Municipal Licensing and Standards

**Re: Sidewalk/Boulevard Cafe Application – File #B066305**

I am writing in reference to your application for Sidewalk/Boulevard Cafe privileges on the commercial frontage of 770 St Clair Avenue West.

770 ST. CLAIR W

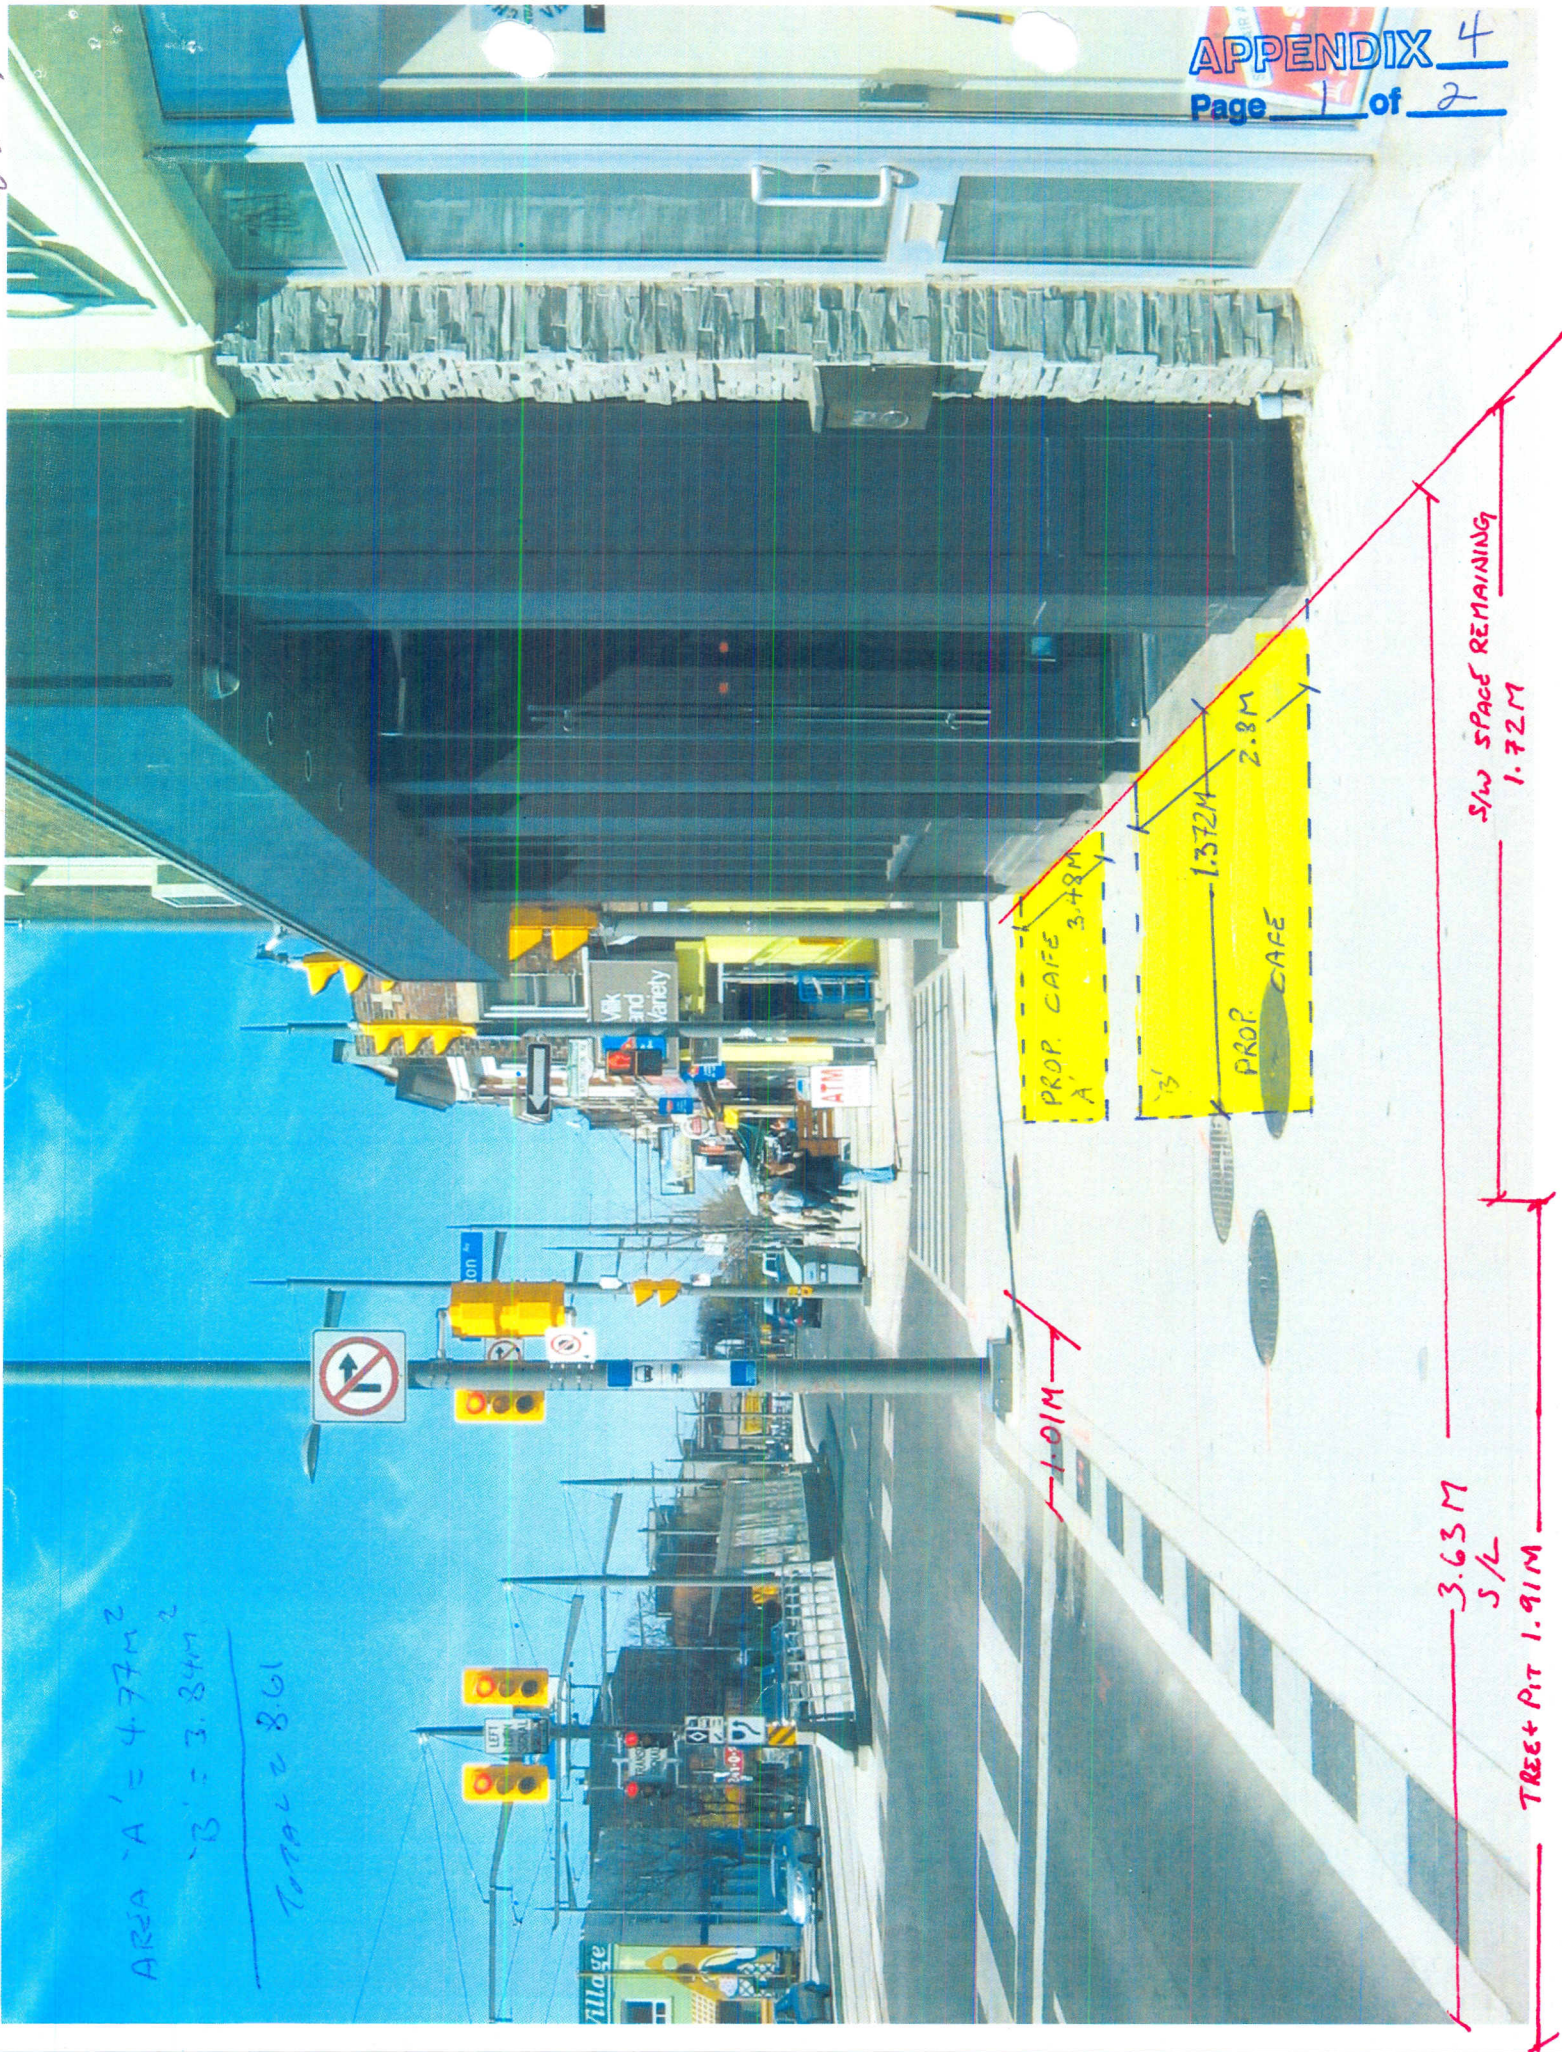
Boulevard cafes are governed by the criteria set out in Chapter 313 of the former City of Toronto Municipal Code. One of the provisions of the Code is that boulevard cafes shall provide 2.13 meters clearance from the curb and/or any street furnishings (i.e. tree planters, poles, and benches...) in order to maintain adequate pedestrian space.

A review of the proposed location has determined taking into consideration the clearance requirement described above, that there is insufficient space to operate a boulevard café at this location. Therefore, your application has been refused as applied.
